UNITED STATES PATENT AND TRADEMARK OFFICE

09/677,870

Office Action Summary

DETAILED ACTION

Fig. 10

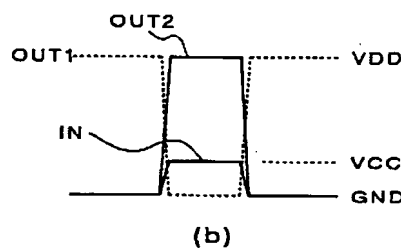
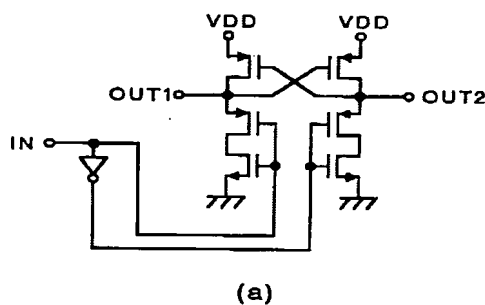
As a courtesy, cited but not applied is Matsueda, US PG PUB 2002/0145602. Matsueda provides in Figure 10 a plot of the difference between the input signals and output signals of a transistor driver circuit as used in an LCD. Many variations of transistor driving exist in the art, but they all have outputs that are different from both of the inputs.

Figure 10(b) clearly shows Out1 and Out2 are not the same, and clearly they are not the same as the driving signals, IN [varies between VCC and GND] applied to the gate electrodes, and VDD [as the data signal of a data line] applied to the source electrodes. Out1 and Out2 are entirely different signals produced by amplification resulting from the applied inputs at the gate and source electrodes. Out1 and Out2 are NOT the same as the gate signal and they are NOT the same as the data signal. Passive matrix displays apply row and column voltages directly to the pixels; active matrix displays to not.

FIG. 19A

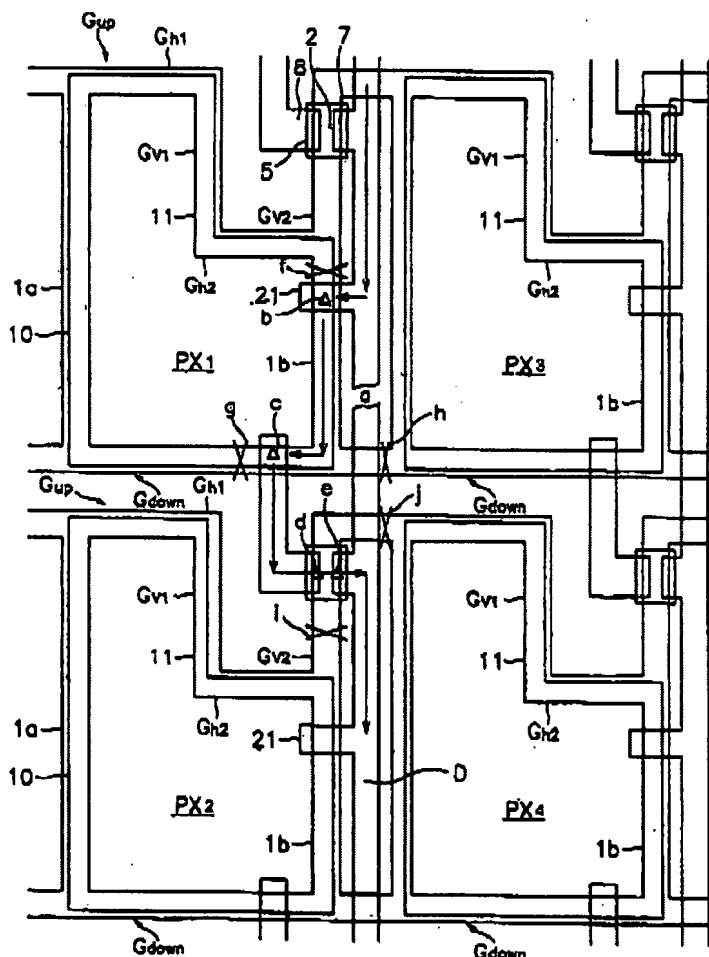
Song teaches 1) and 3) the use of a redundant pattern that is integrated with the gate line and branches from the gate line in Figure 19A (G_{up} and G_{down} or 1a and 1b) wherein a dummy pattern extends substantially the entire length of the pixel electrode portion adjacent and parallel to the data line [portion running under right edge of pixel electrode in Figure 19A from below $Gv2$ to the horizontal portion between g and h] wherein the gate dummy patterns are physically located separate and apart from the gate lines [separated by cutting at the "X" marks, f and g, in Figure 19A], as a redundancy electrode for electrically connecting the gate line to the broken data line (col. 17, lines 4-67, especially col. 17, lines 47-54) to effect repairs.

Song is evidence that ordinary workers in the art of liquid crystals would find the reason, suggestion, or motivation to form the gate dummy pattern in such a manner as to serve as a redundancy electrode, wherein the gate dummy patterns are physically located separate and apart from the gate lines, for electrically connecting the gate line to the broken data line to effect repairs.

FIG. 13

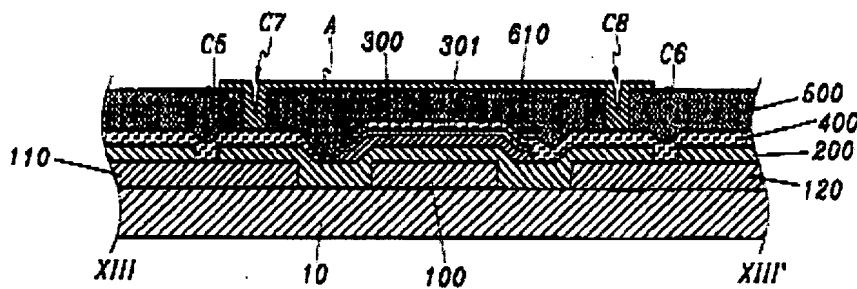
Kim teaches in Figure 13 wherein when the data line is broken, the use of forming holes and connections to the repair lines, 110 and 120, (Applicant's gate dummy pattern) and to a connecting pattern, 610, to repair a broken data line, 400, (col. 8, lines 1-15).

FIG. 26

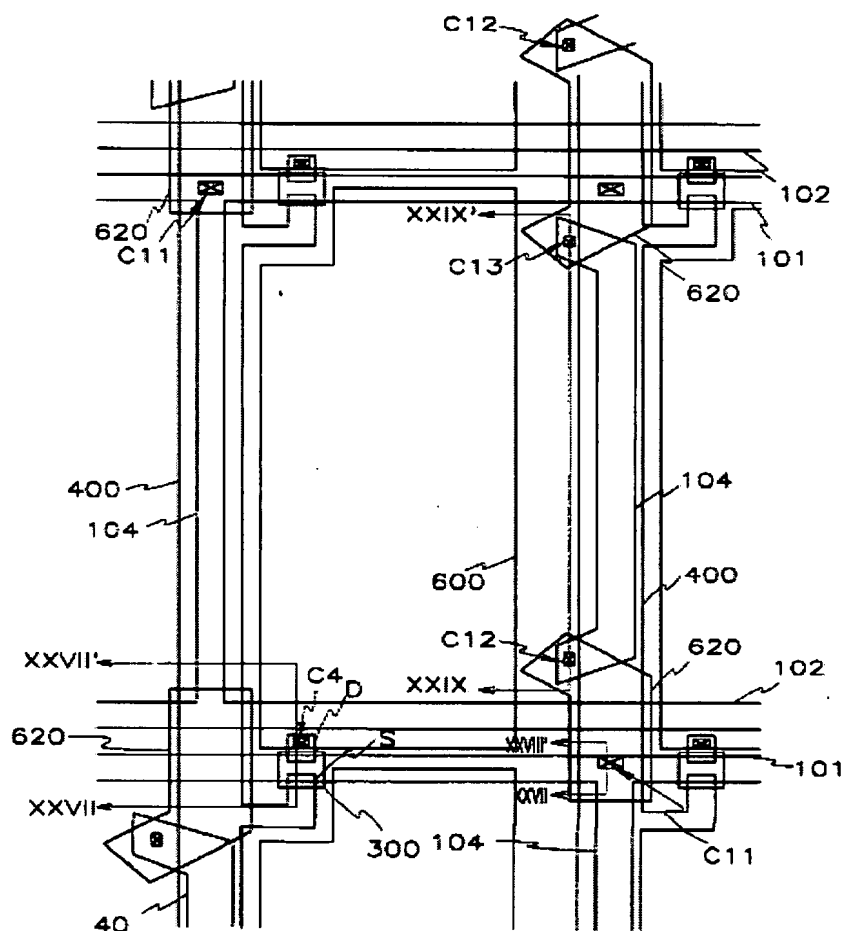
Kim teaches in Figure 26 the use of repair lines, 104, (Applicant's gate dummy pattern used as a redundancy electrode) to connect the gate line to the data line (col. 13, lines 4-17).

FIG. 19A

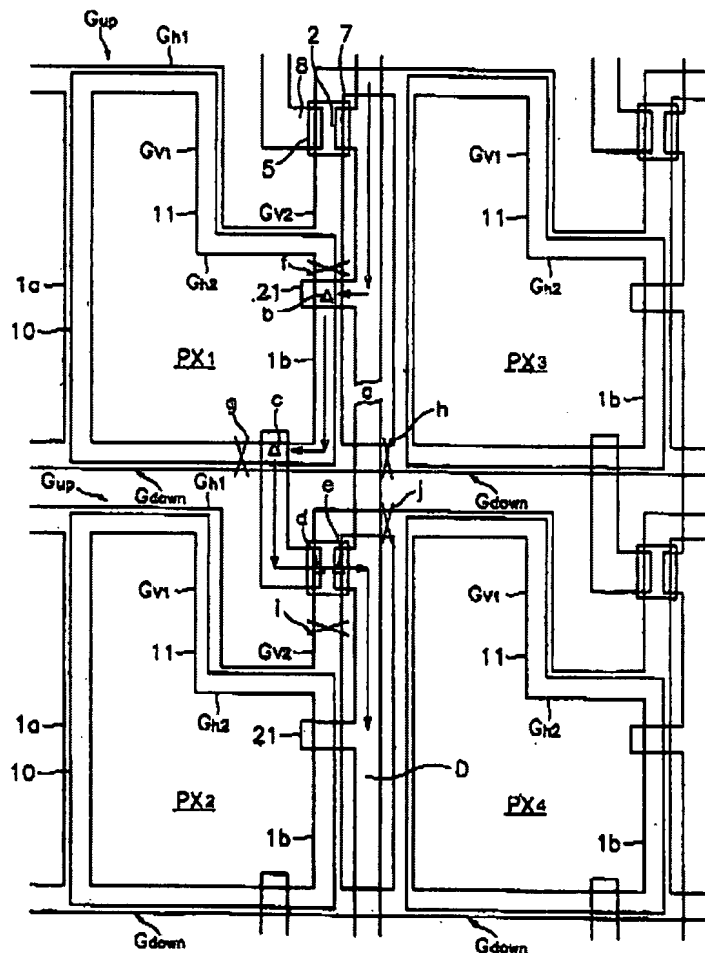
Song teaches, wherein when the data line is broken, the use of a redundant pattern in Figure 19A (G_{up} and G_{down} or 1a and 1b) as a redundancy electrode for electrically connecting the broken data line (col. 17, lines 4-67, especially col. 17, lines 47-54) to effect repairs.

FIG. 18

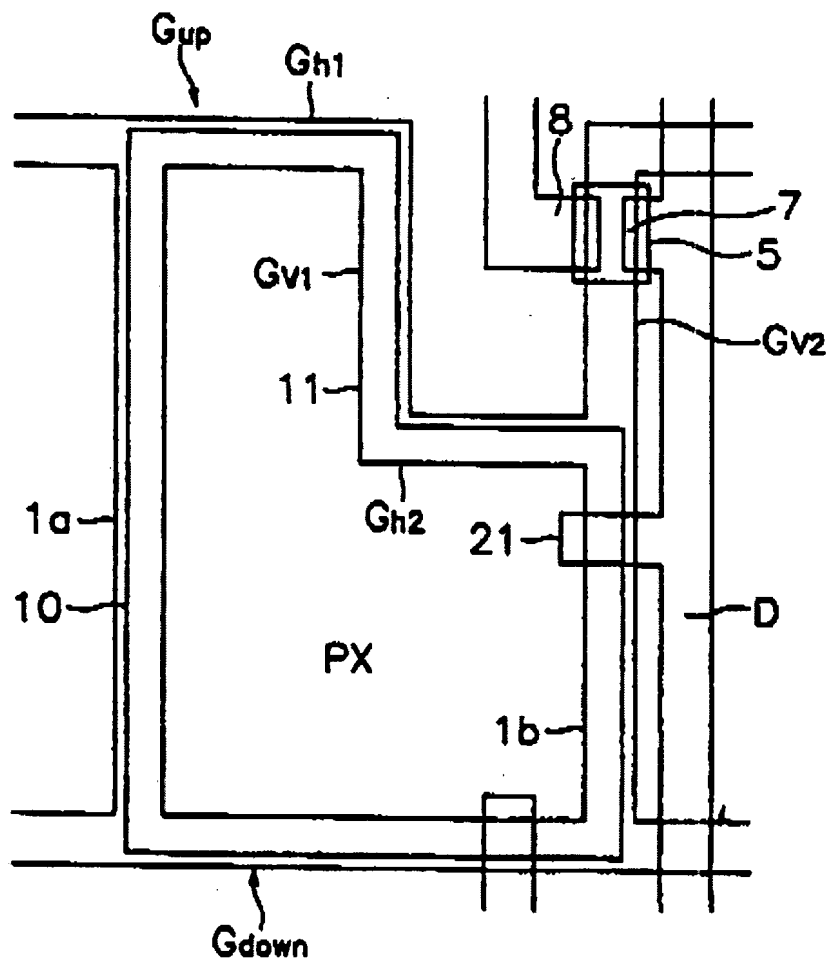
As to claims 6, 15, 22, and 24, and Song teaches in Figure 18 a thin film transistor substrate further comprising: a storage capacitor (col. 15, lines 56-64) defined by a horizontal overlapping part, G_{h2} , between the gate line and the pixel electrode, PX. Song also teaches in Figure 18 an analogous overlapping portion, 21, of the data line, D, to permit a repair. Also, any two conductors separated by an insulator result in a capacitor as a matter of physics. Therefore the overlap region between the pixel electrode and the dummy pattern which are separated by an insulator necessarily forms a capacitor.

As to claims 7 and 16, Song teaches in Figures 18 and 19A a protrusion, 21, protruded from the data line in such a manner to overlap with the intended repair site

Fig.2 PRIOR ART

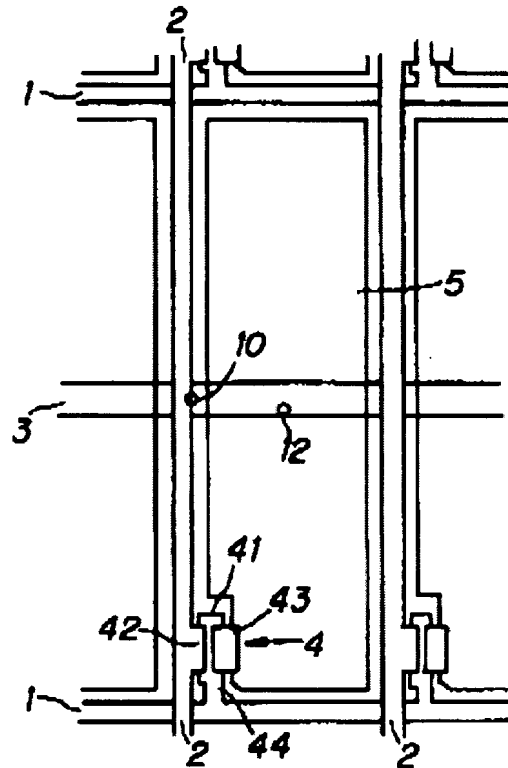
(5) It is respectfully pointed that recess is on the left side of the narrow part, 44, that leads to the gate electrode, 41, in Figure 2 below:

The teaching of Irie would be more than sufficient to render the use of a recess obvious to one having ordinary skill in the art at the time the claimed invention was made, and as evidenced by the prior art, would not be confusing with respect to the need for light blocking layers (no teaching away). One skilled in the art does not forget fundamentals (like light blocking) when incorporating an added feature (like a recess/narrowed portion). Examiner cannot see any reason to believe one of ordinary skill in the art would be mislead into creating an inoperable device based upon the combination of applied prior art. Examiner has considered all of Applicant's arguments and conclusory statements and maintains rejections are proper. Applicant's burden to overcome rejections is covered in the MPEP. It is respectfully pointed out that
